BOARD ACTION REPORT – APPEALABLE ITEM

Project Name: Atlantic Crossing (Building I & III) (2021-200)

Request: Class I Site Plan Modification

Meeting Date: August 25, 2021

BLDG III ELEVATIONS

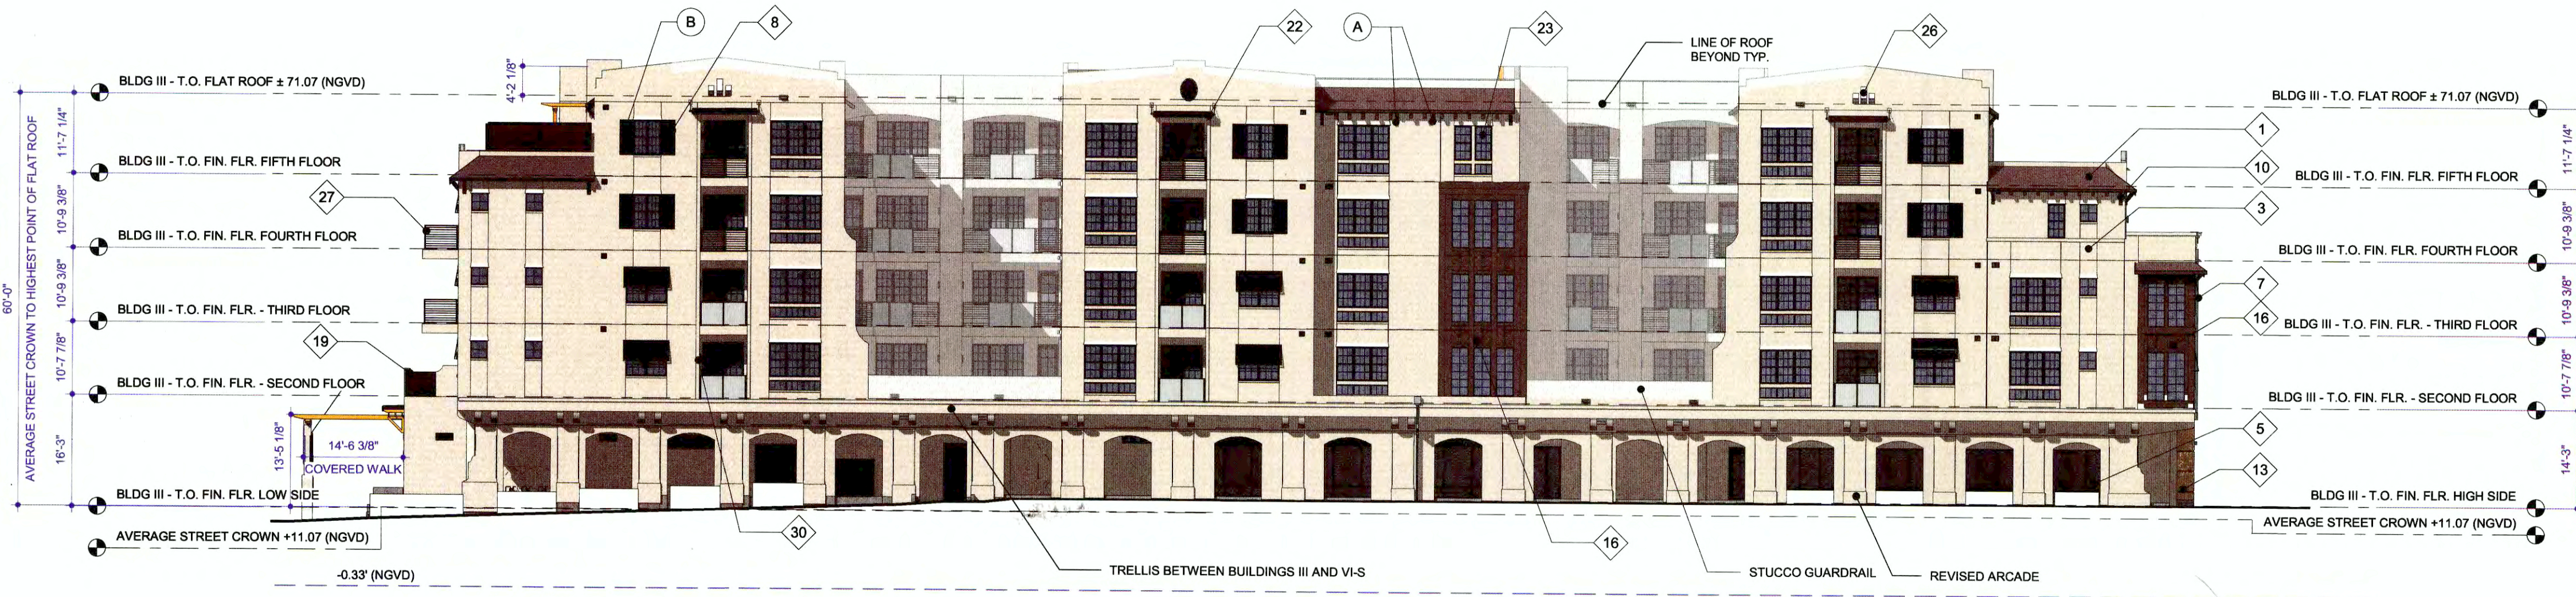
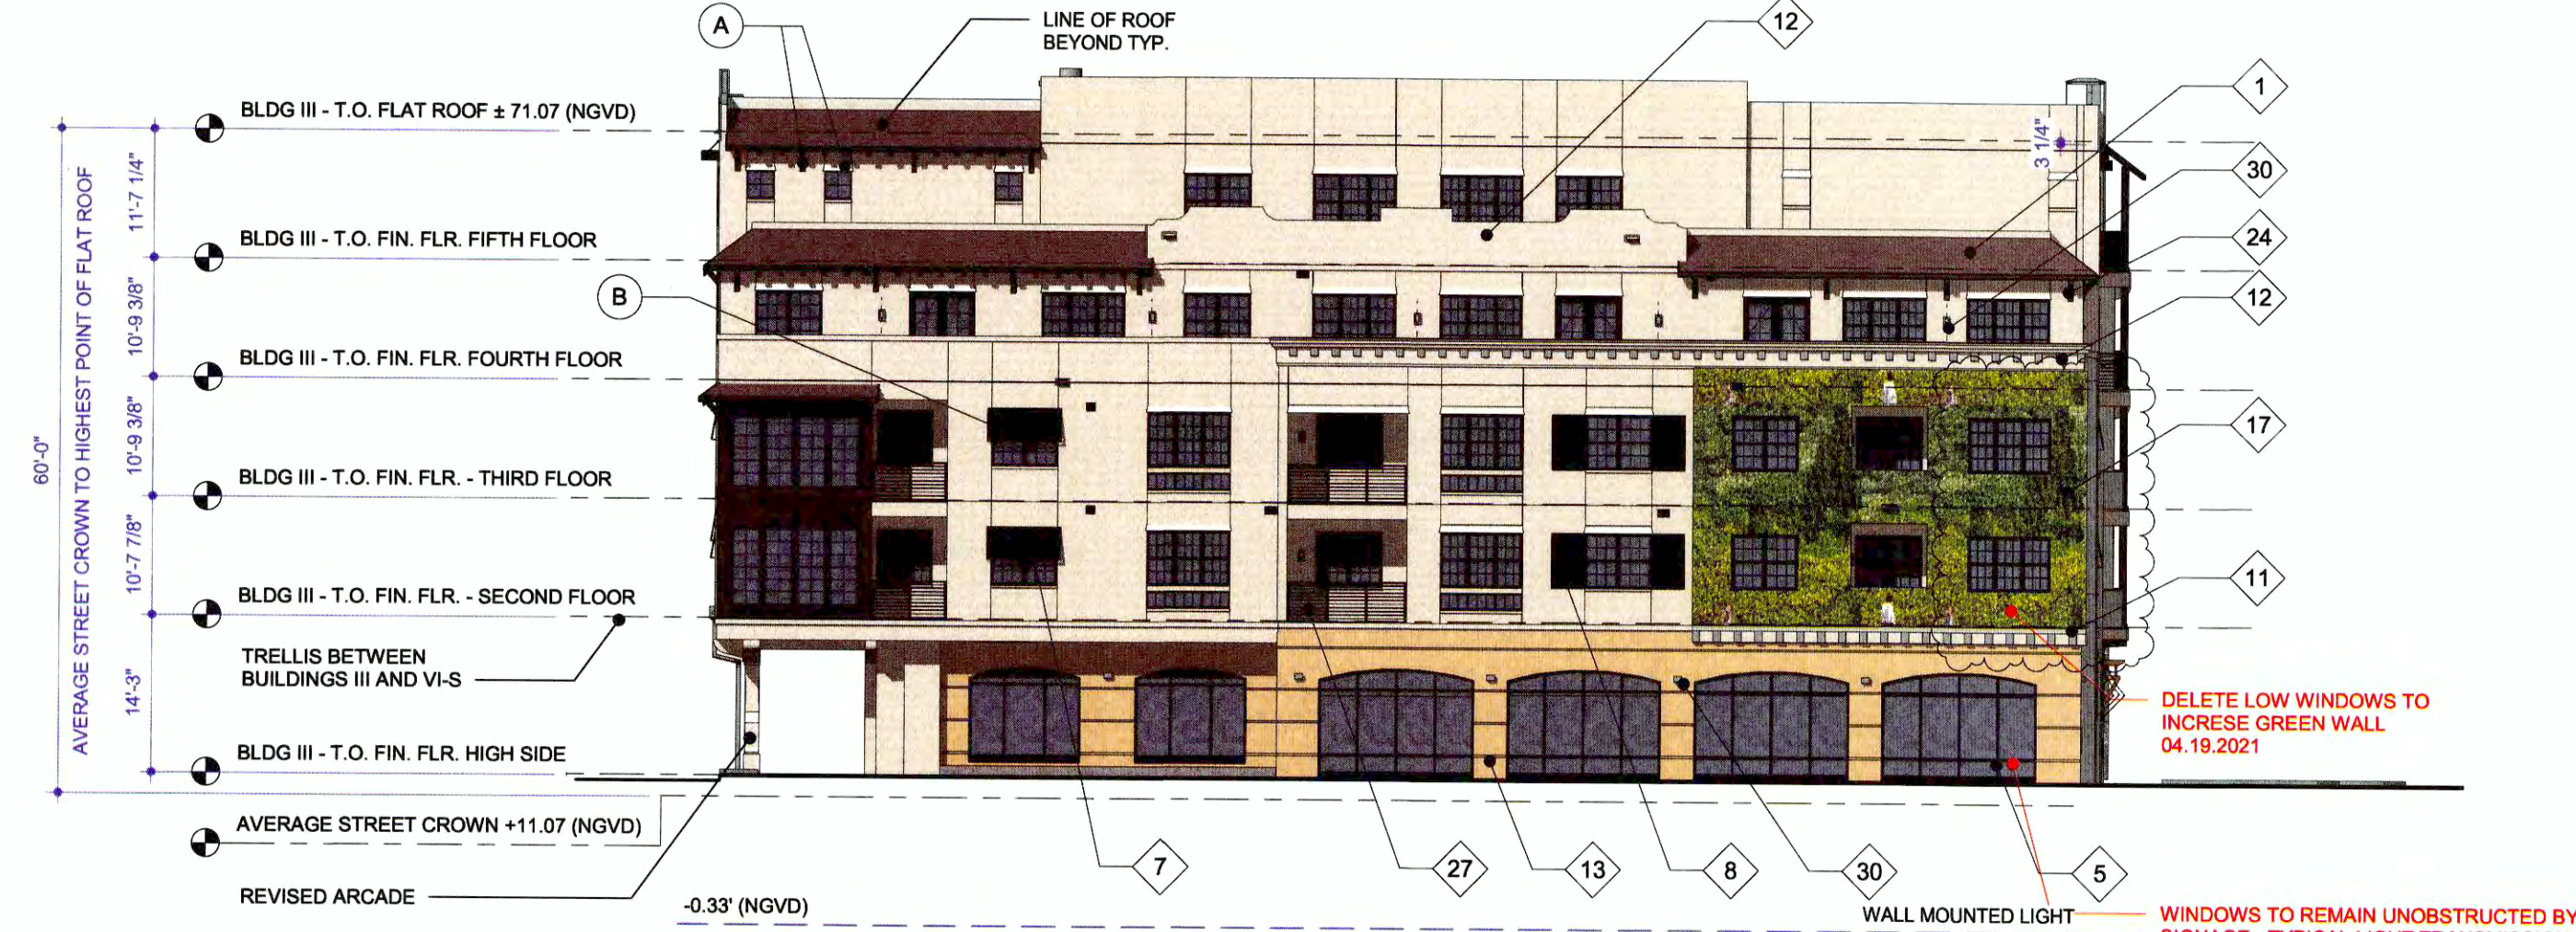
CLASS I MODIFICATION 10.26.2020

- REVISE ENTRY AT THE SOUTH EAST CORNER OF THE BUILDING
- REMOVE LOW WINDOWS AT SOUTH WEST CORNER OF THE BUILDING TO INCREASE GREEN WALL AREA

CLASS I MODIFICATION 04.19.2021

- REVISE WINDOWS AT GREEN WALL
- REVISED ENTRY AT EAST RESTAURANT
